LRN-03-0274
LCR S03-08

**REQUEST FOR CHANGE TO OPERATING LICENSE
LICENSE CONDITION 2.C.10 'FIRE PROTECTION'
SALEM GENERATING STATION UNIT NO. 2
FACILITY OPERATING LICENSE NO. DPR-75
DOCKET NO. 50-311**

**EVALUATION OF REVISIONS TO THE OPERATING LICENSE FOR
FIRE PROTECTION AT SALEM UNIT 2**

**REQUEST FOR APPROVAL OF CHANGES TO THE POST-FIRE SAFE
SHUTDOWN STRATEGY FOR FIRE AREAS 2-FA-AB-64B, 2-FA-AB-84C,
AND 2-FA-AB-84B
SALEM GENERATING STATION UNIT 2
DOCKET NO. 50-311
FACILITY OPERATING LICENSE NO. DPR-75**

Figure 1
LR-N03-0249

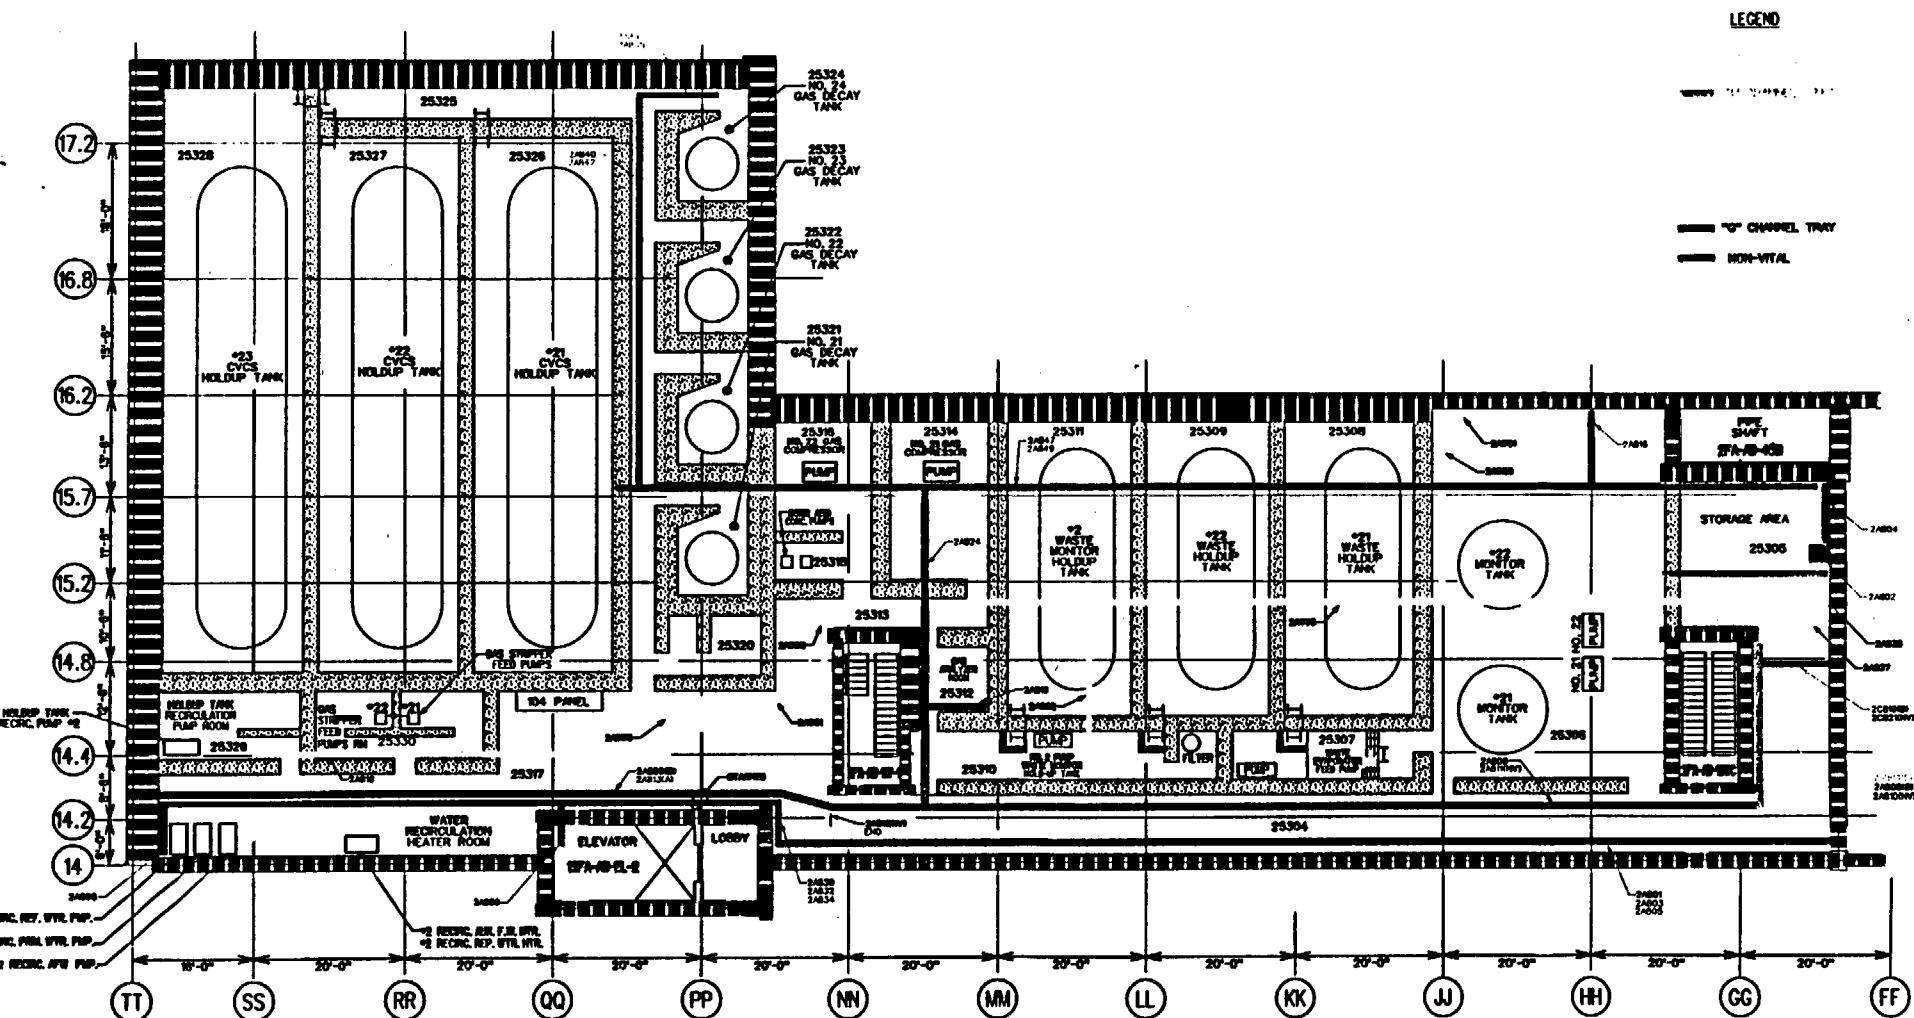
In accordance with Salem Unit 2 License Condition 2.C.10, PSEG Nuclear LLC (PSEG) requests NRC approval of changes to the post-fire safe shutdown (SSD) strategy for Fire Area 2-FA-AB-64B. The new SSD strategy changes this area from a normal shutdown area (10 CFR 50 Appendix R III.G.2) to an alternate shutdown area (10 CFR 50 Appendix R III.G.3). The requirements of 10 CFR 50, Appendix R, Section III.G.3 are being deviated from in that a fixed suppression system is not installed for an area where alternative shutdown capability is provided. Specifically, Fire Area 2-FA-AB-64B, Reactor Plant Auxiliary Building – Elevation 64', is not provided with a fixed suppression system.

In addition, PSEG is deviating from the requirements of 10 CFR 50 Appendix R, Section III.L.3 to the extent that alternative shutdown capability must accommodate conditions where offsite power is not available for 72 hours. Specifically, Fire Area 2-FA-AB-64B, Reactor Plant Auxiliary Building – Elevation 64', relies upon offsite power for alternative shutdown capability.

The Reactor Plant Auxiliary Equipment Area (Elevation 64') of the Auxiliary Building contains waste gas compressors, waste gas tanks, storage tank recirculation pumps, and holdup tanks and pumps. See Figure 1.

- Use of alternative shutdown capability, independent of the fire area, in the form of the Chemical and Volume Control System (CVCS) cross-tie from the unaffected unit for seal injection, boration, and inventory control (modification discussed in Attachment 4).
- Use of off-site power. A fire in this area has the potential to result in a loss of the emergency diesel generators to the 4160V vital buses. However, offsite power to the 4160V vital buses has been evaluated and is not affected by a fire in this area and therefore, will remain available to provide power to safe shutdown components. The use of offsite power, in lieu of on-site emergency diesel generators, is considered an acceptable alternative to the requirements of Section III.L.3 of 10 CFR 50 Appendix R.

- The area has low combustible loading and limited ignition sources.
- The area is provided with a detection system that is adequate for the fire hazards within the area. The detection system would alert operators to summon the on-site plant fire department to rapidly extinguish the fire.
- Alternative shutdown capability, independent of the fire area, is provided to ensure post-fire safe shutdown.
- Offsite power remains available for a fire in this area.

It is, therefore, PSEG's position that a level of protection equivalent to Sections III.G.3 and III.L.3 of Appendix R to 10 CFR 50 is provided. The installation of a fixed suppression system would not significantly enhance the level of fire protection for safe shutdown capability. The use of offsite power, in lieu of on-site emergency diesel generators, is considered an acceptable alternative.

Figure 3
LR-N03-0249

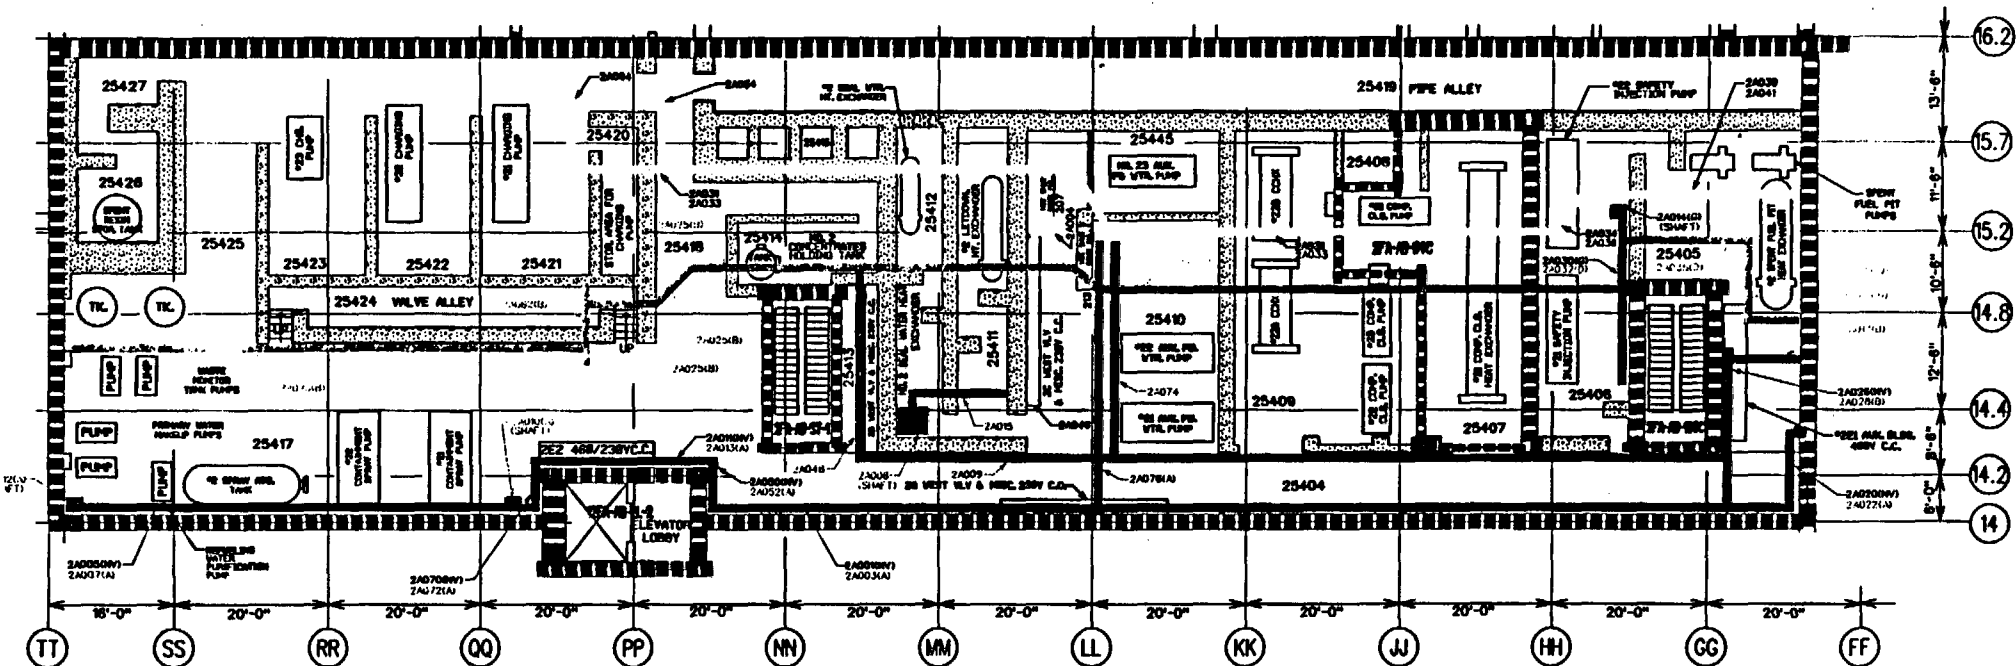
A listing of safe shutdown components in this area is provided in Attachment 9 with the room locations identified in Figure 3.

The Reactor Plant Auxiliary Equipment Area (Elevation 84') of the Auxiliary Building, contains pumps, heat exchangers, tanks and control centers for the chemical and volume control, component cooling, safety injection, containment spray, auxiliary feedwater, waste disposal, and spent fuel pool cooling systems. See Figures 3 and 4.

A listing of safe shutdown components in this area is provided in Attachment 10 with the room locations identified in Figure 3.

Figure 4

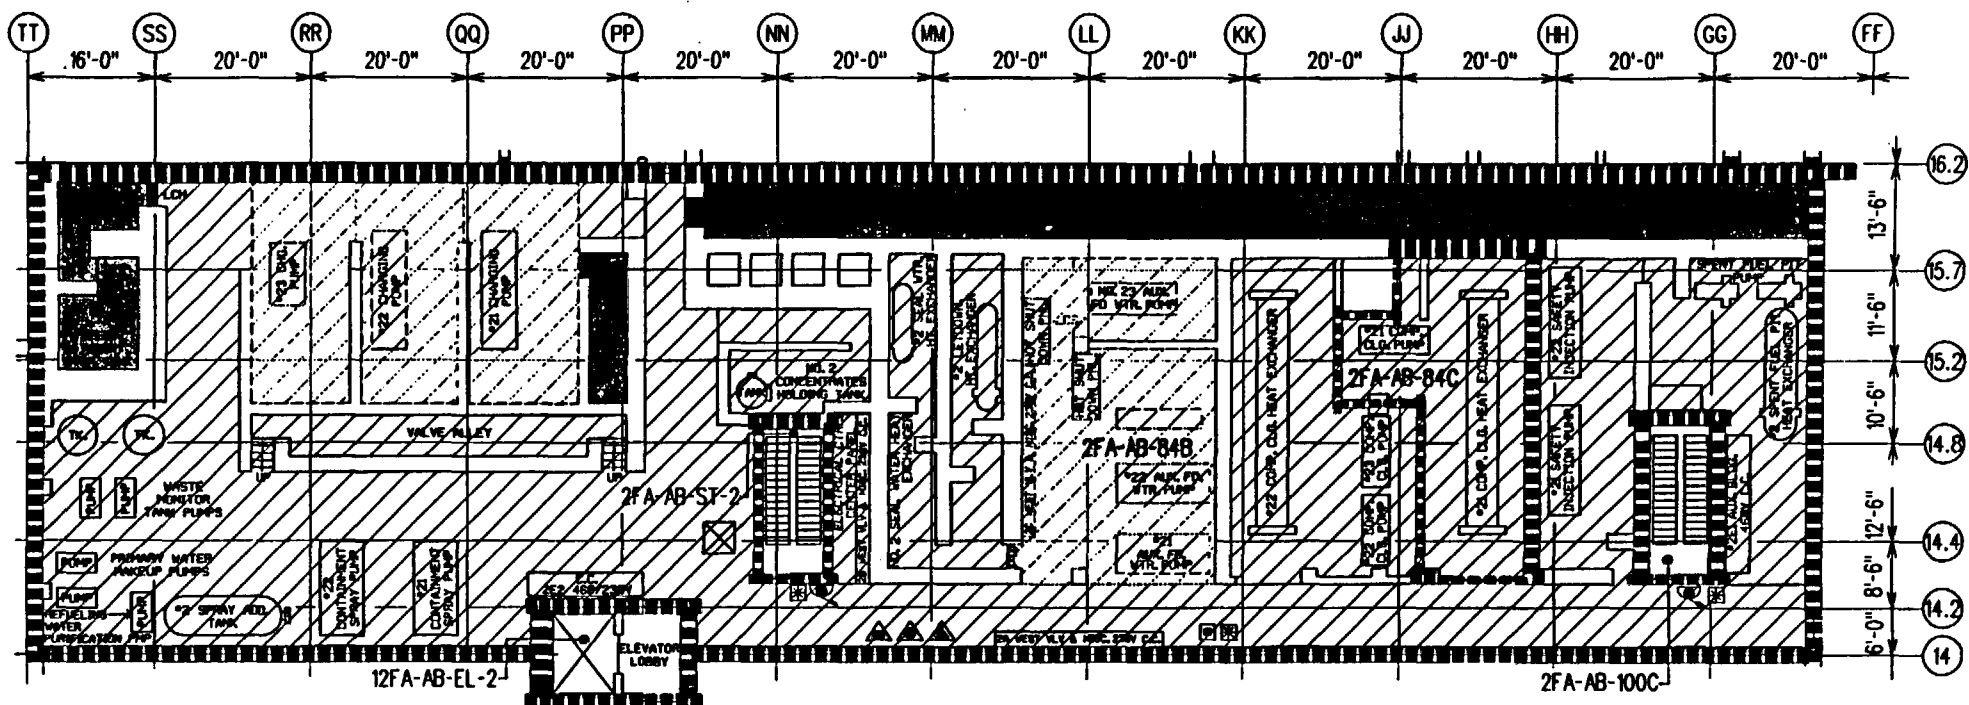
An area wide detection system is installed in the area (See Figure 4). The detection system has been evaluated as adequate for the hazards. Detectors alarm in the Control Room.

Partial area detection is provided in the ceiling in the Safety Injection and Component Cooling Water pump areas, Charging and Containment Spray Areas, Spent Fuel Pool Heat exchanger areas as well as various corridors (See Figure 4). Detectors are located in the vicinity of major hazards. The fire detection system has been evaluated in accordance with Generic Letter 86-10 and is considered adequate for the fire hazards in the area. In addition, the staff concluded in their July 20, 1989 Safety Evaluation that the summary analyses contained in the exemption requests were sufficient to satisfy the Generic Letter 86-10 partial detection evaluation guidelines.

Fire suppression is provided for the Auxiliary Feedwater pumps by automatically actuated redundant pre-action sprinkler systems. Fire suppression is provided for the charging pump area by a wet pipe sprinkler system. (See Figure 4) The fire suppression systems have been evaluated in accordance with Generic Letter 86-10 and are considered adequate for the fire hazards in the area. In addition, the staff concluded in their July 20, 1989 Safety Evaluation that the summary analyses contained in the exemption requests were sufficient to satisfy the Generic Letter 86-10 partial suppression evaluation guidelines.

Figure 5
LR-N03-0249

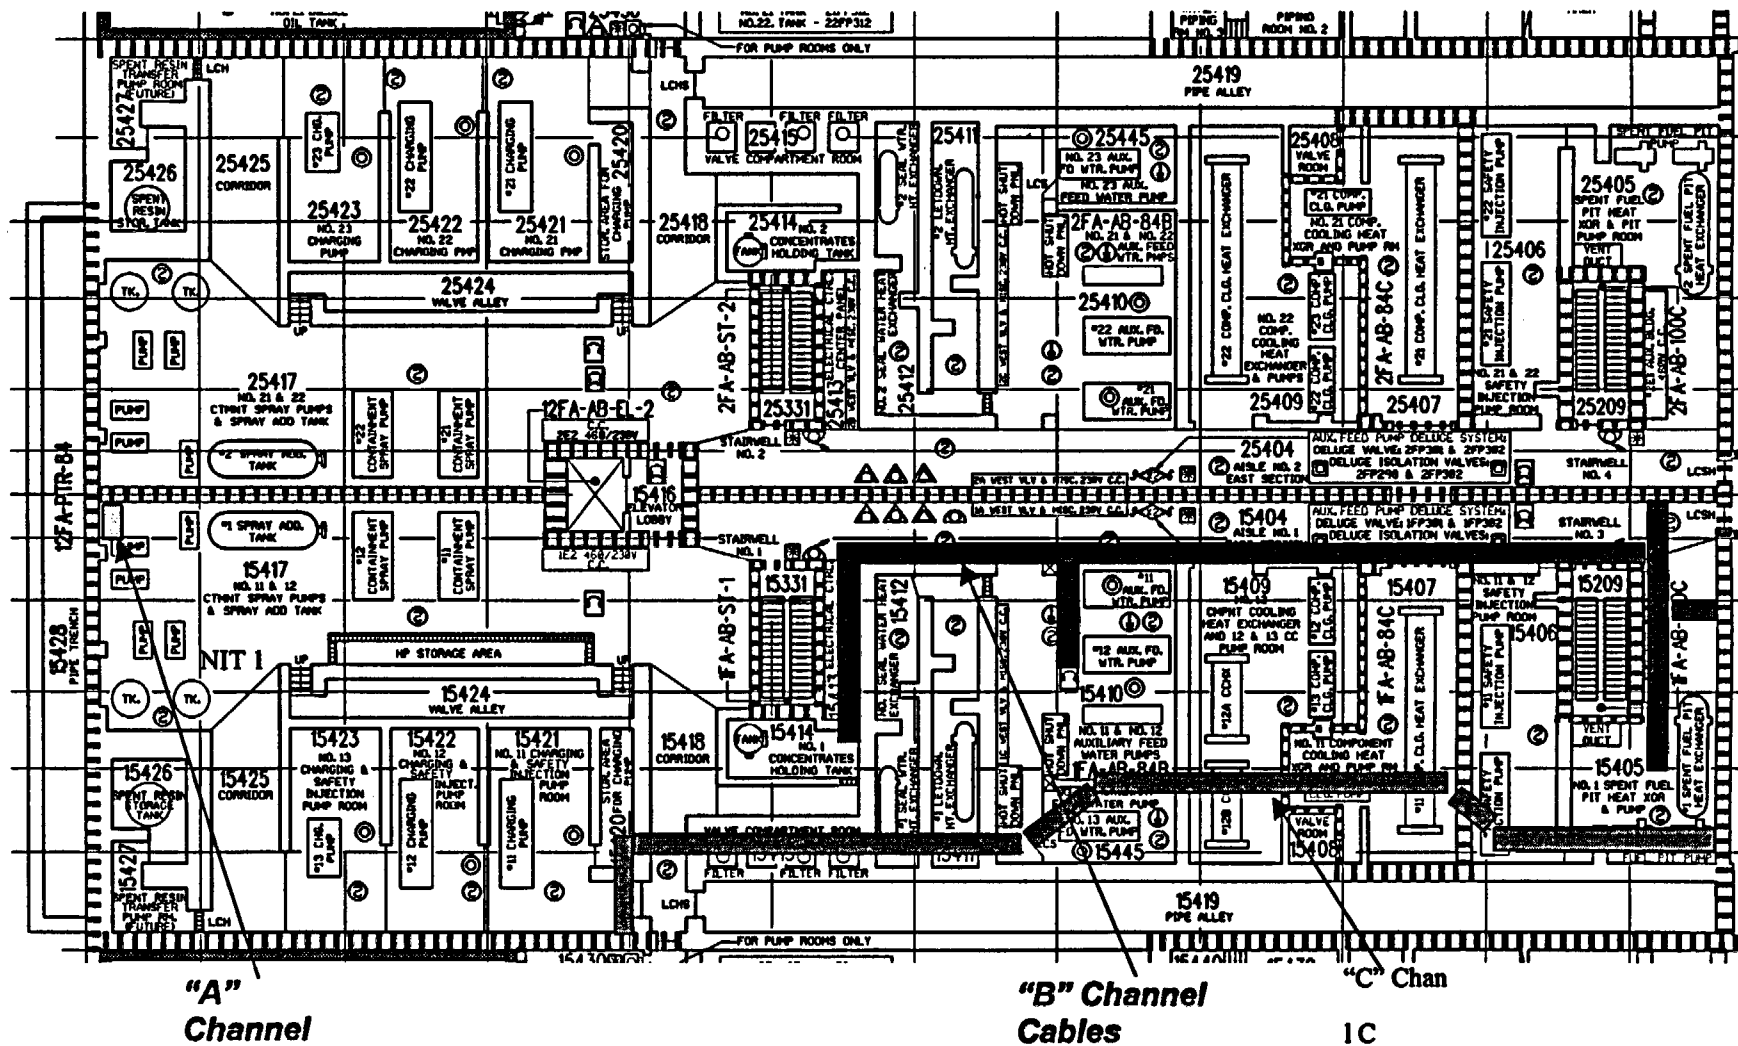
The Service Water system cabling for all six Service Water pumps is routed through this area (see Figure 5). Service Water is required to bring the plant to hot standby and cold shutdown. To ensure the availability of the Service Water for hot standby, an evaluation has been performed that demonstrates that at least two Service Pumps would remain available due to a distance separation of over 75 horizontal feet with intervening combustible loads. This distance separation ensures that either the A-channel Service Water pumps or the B and C-channel Service Water pumps would remain available as discussed below:

To support the above separation evaluation, a review of spurious actuations was conducted to assess the affect on the Service Water function. Based on this review a modification has been performed to the Hot Shutdown Panel to relocate the remote/manual selector switches for the A-channel Service Water pumps. These switches have been relocated out of the Hot Shutdown Panel into another fire area to eliminate any spurious actuations from affecting the ability to use the A-channel Service Water pumps.
